**JEMY DESIGN CORP.
ARCHITECT OF RECORD JOSUE CRUZ
JAVIER R. MARIN, DESIGNER AIA**

FILE NUMBER: 23-DP-52

SUBJECT: Preliminary Site Plan review for mixed-use development including 44 residential units and approximately 1,500 square feet of commercial space (Parkside Vue)

A-002

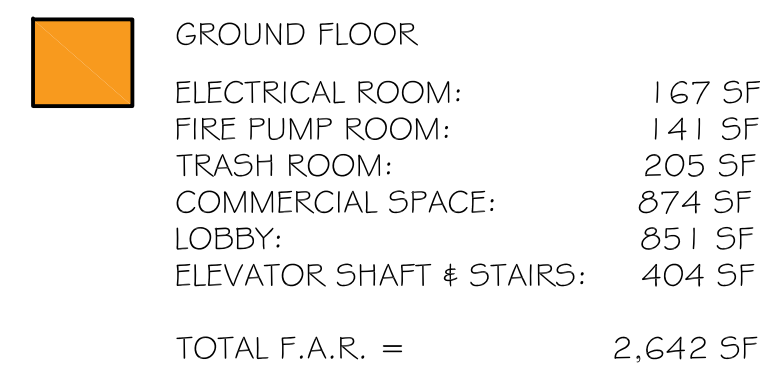
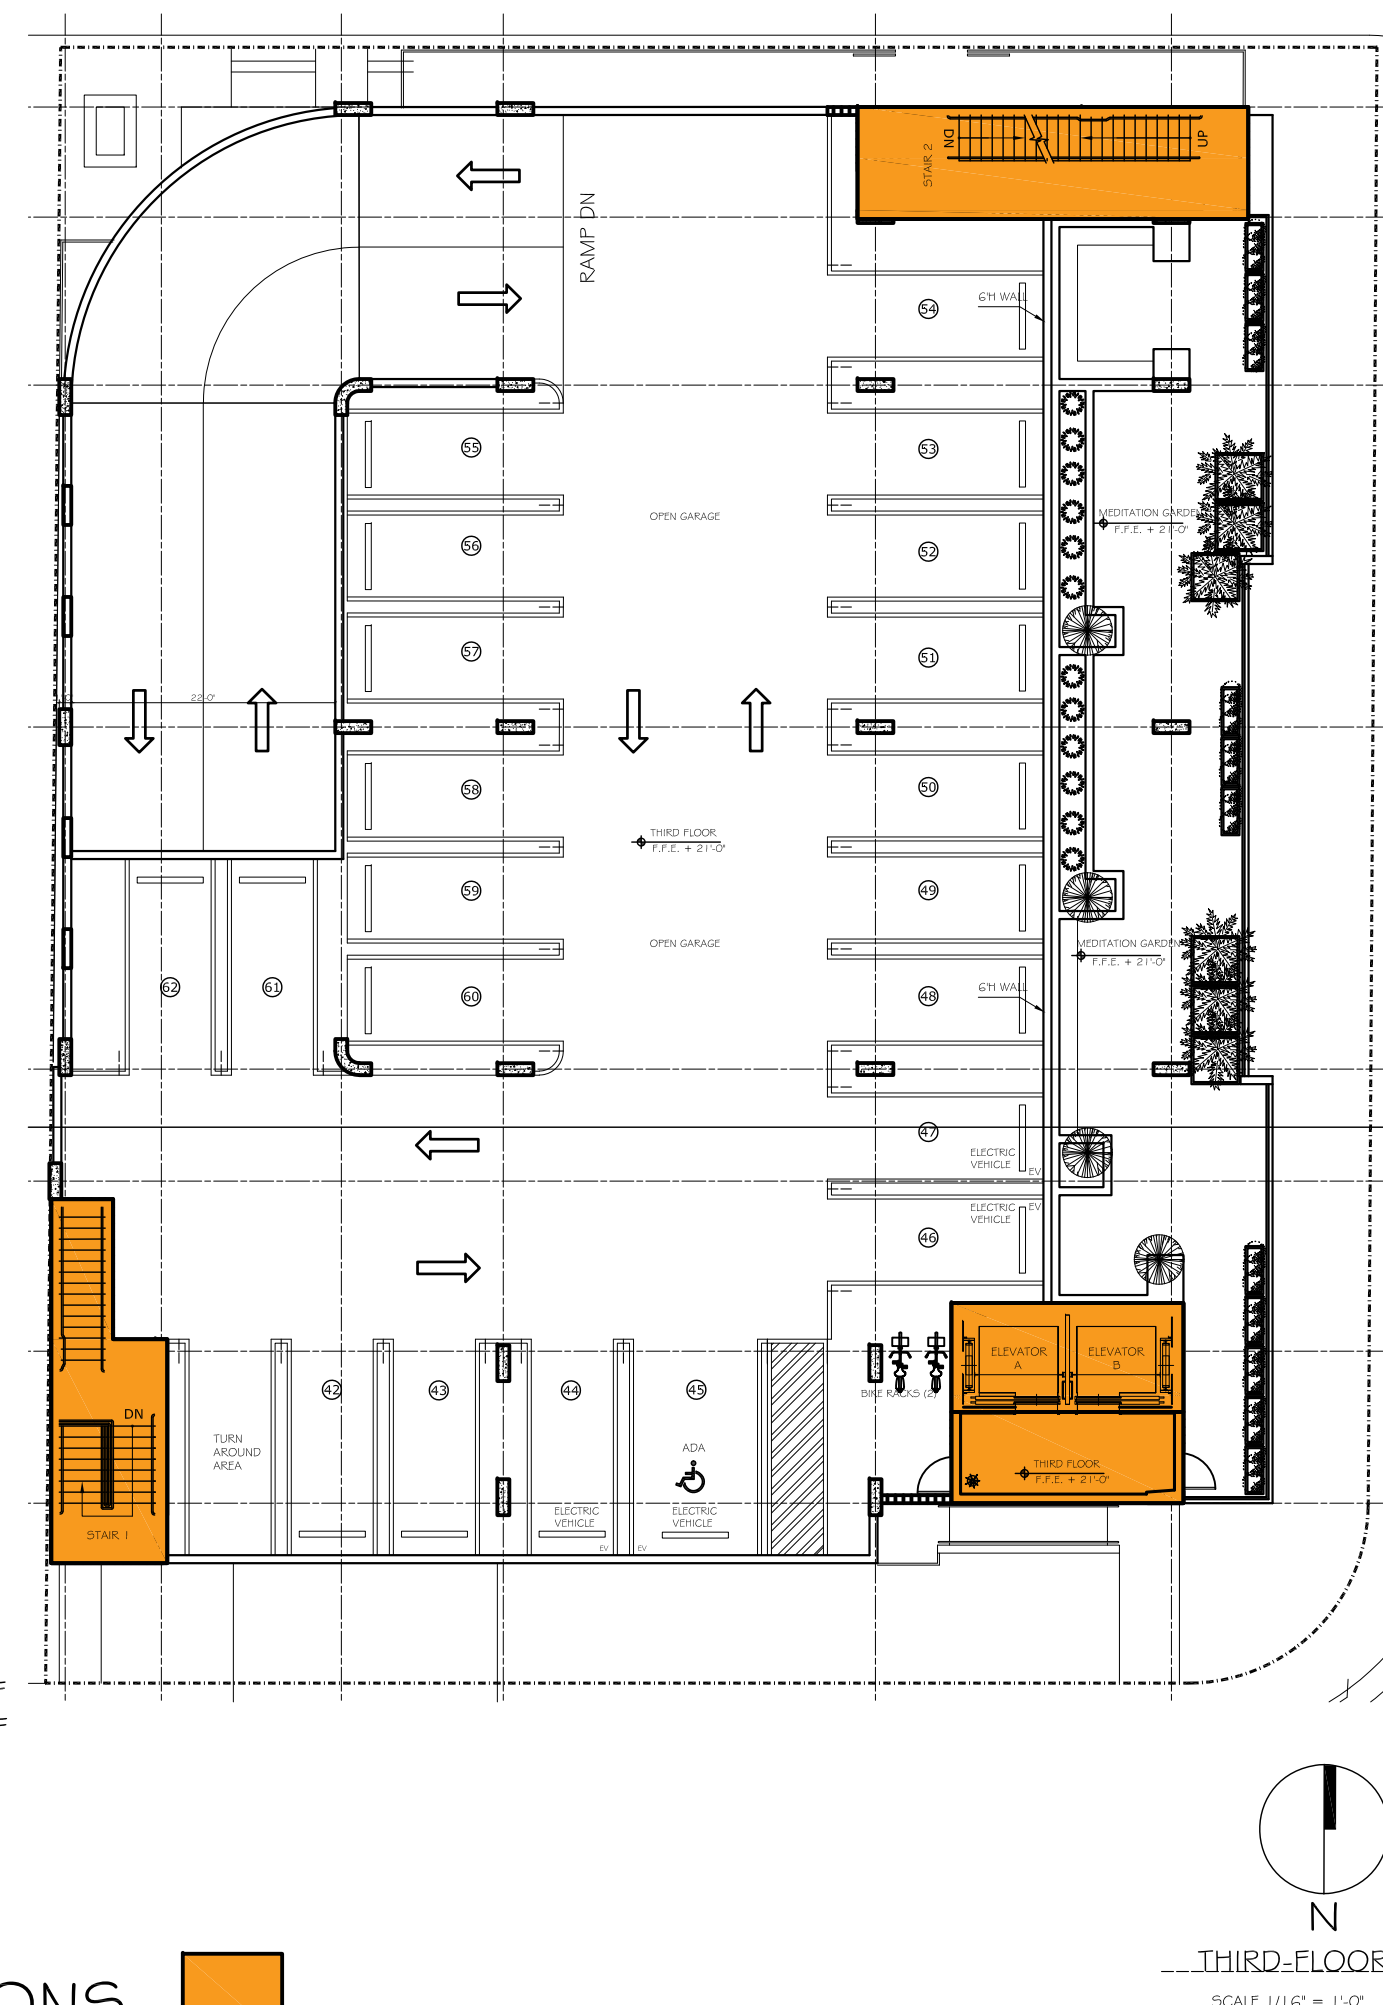
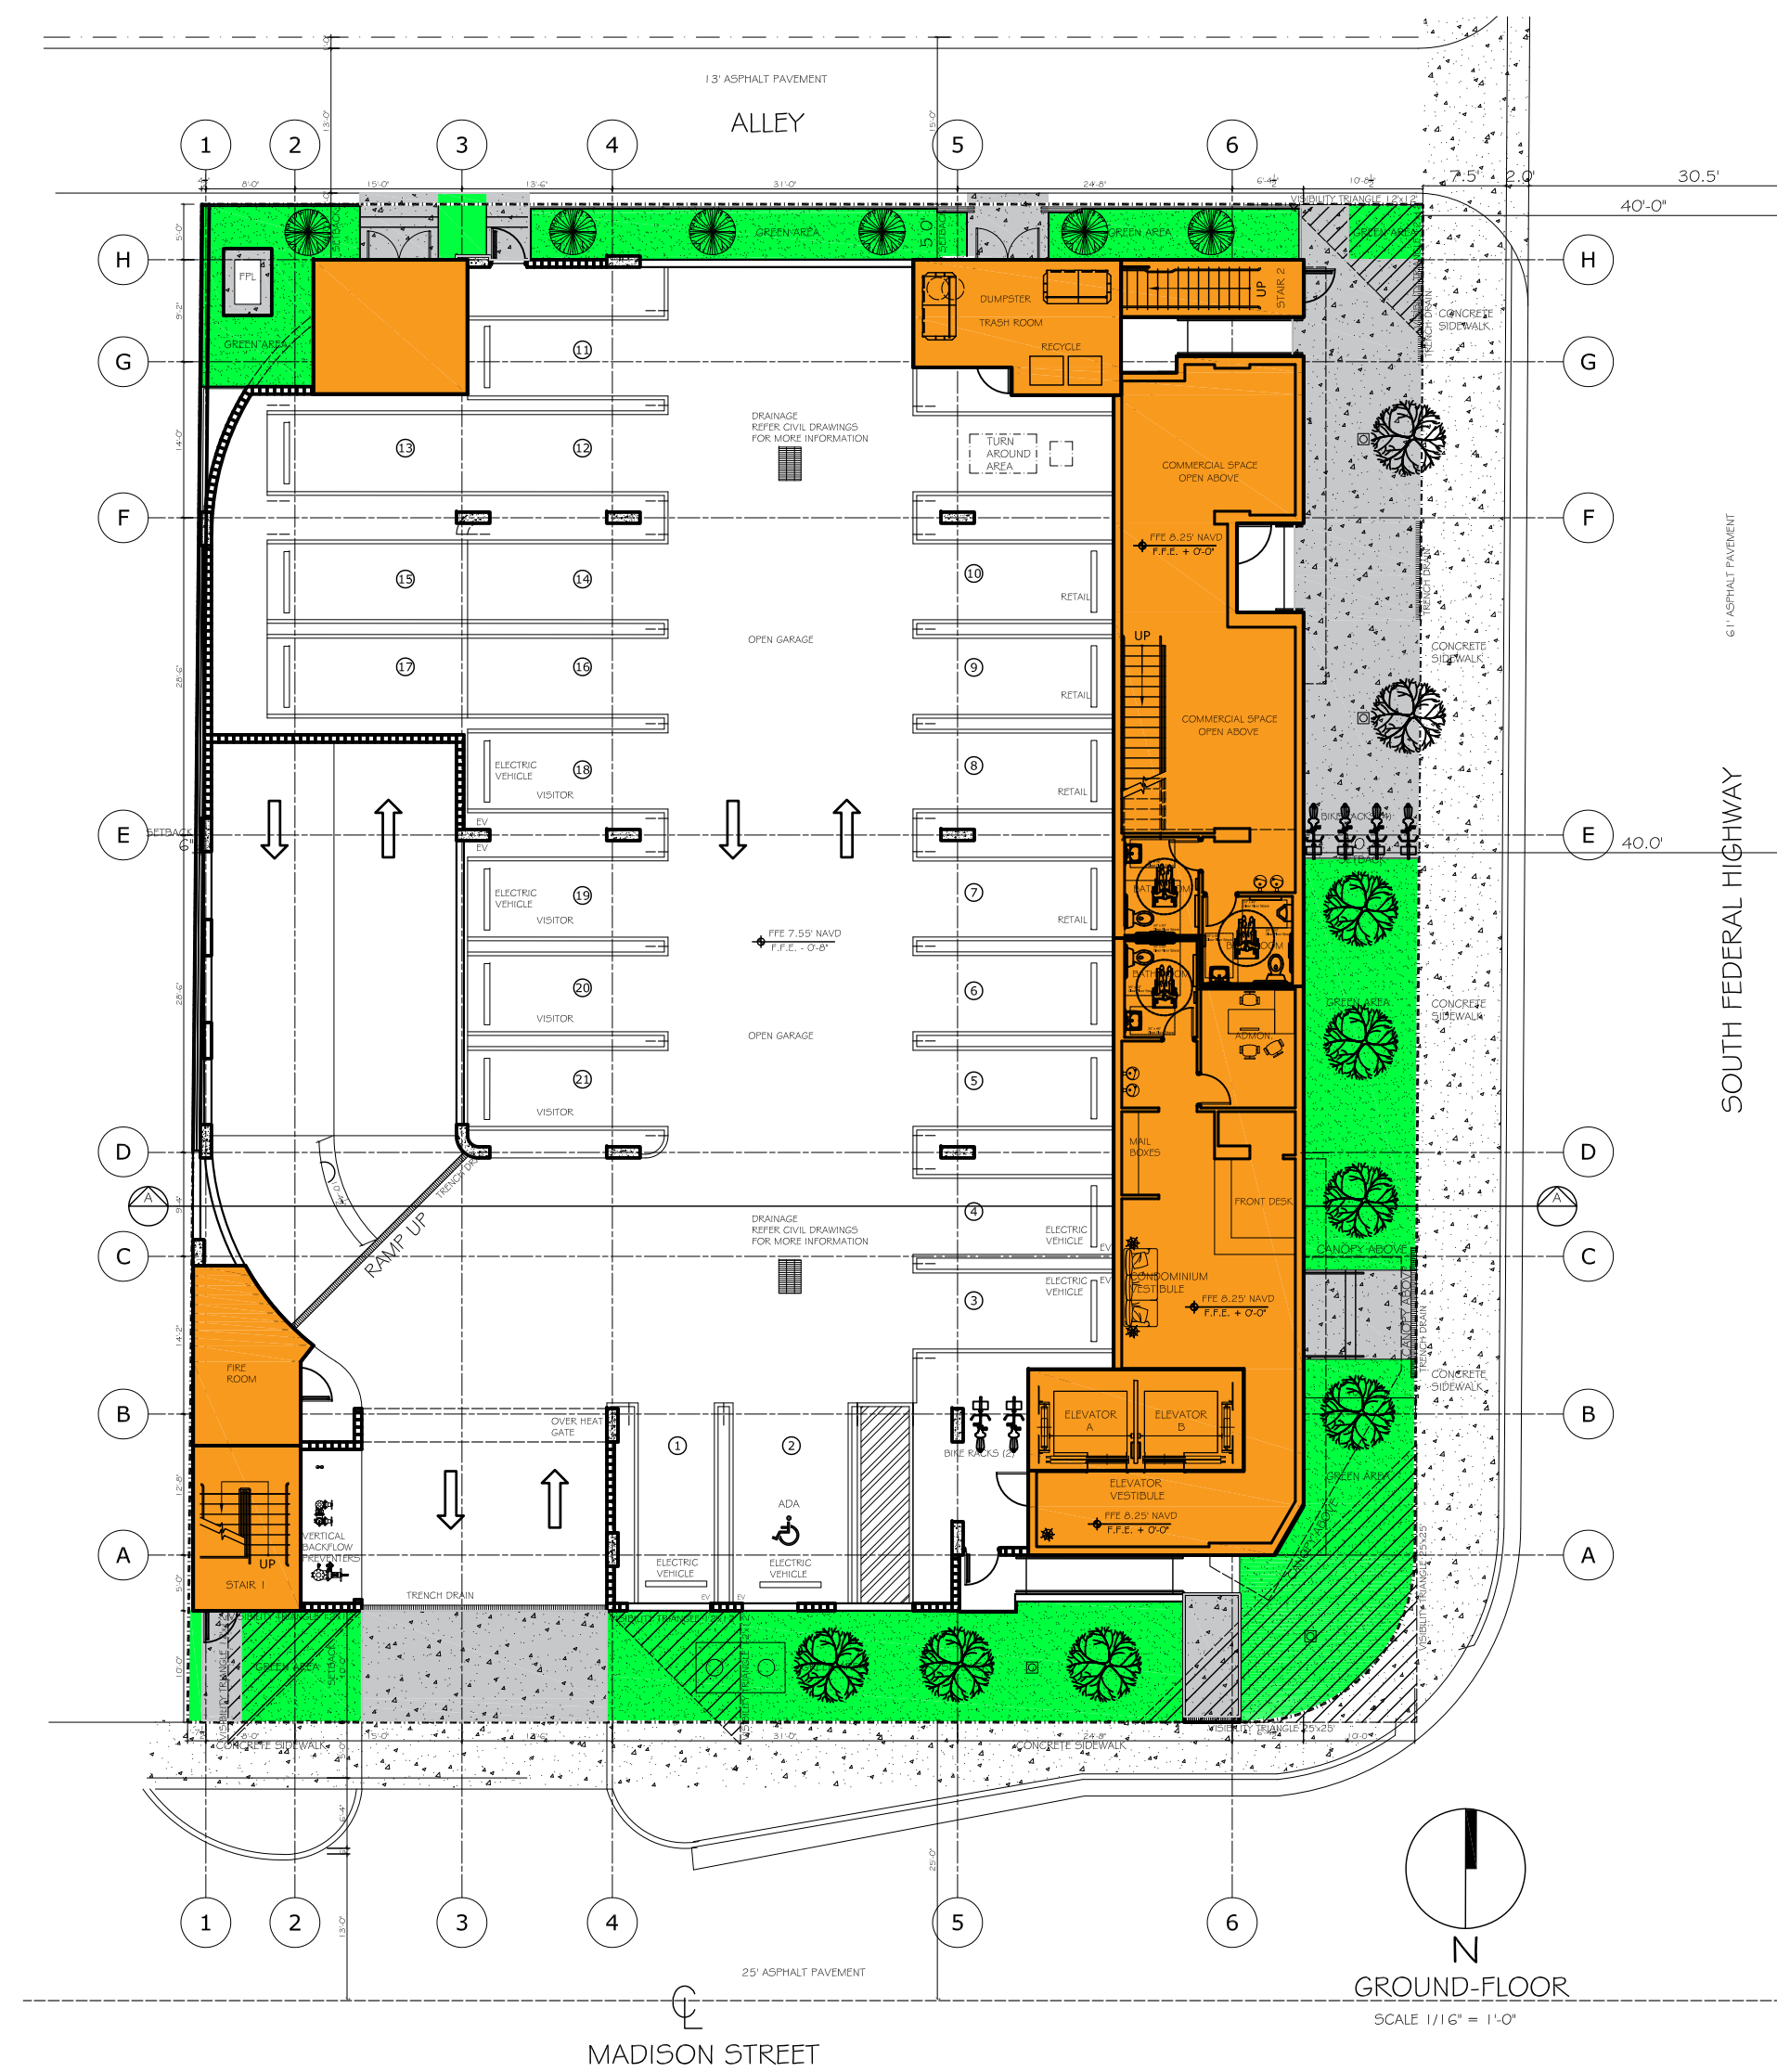
3. Show a diagram how the FAR has been calculated. Please provide on a separate sheet. **PROVIDED A-002**
4. Work with the City's Landscape Architect to ensure that all landscape requirements are met. **UNDERSTOOD**
